# ***Transtech*** **Bulletin**

**Application: General Motors**  
**Subject: 4T65E 1997-UP**

TB 15 12/2000

**TransTec # 12873**  
**OEM #24220217**

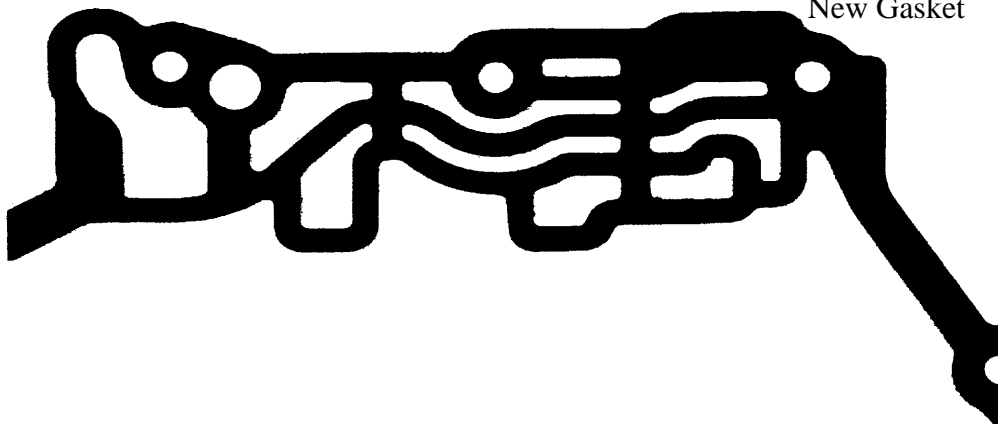
General Motors has altered the case to cover gasket of the 4T65E slightly for all models from 1997-up. The upper case to cover gasket has had an opening eliminated to aid in avoiding potential gasket blowouts.

This is a running change at General Motors and will replace the previous gasket in all models. All kits with date codes of A01 or later will contain the updated gasket. Please see the illustration below.
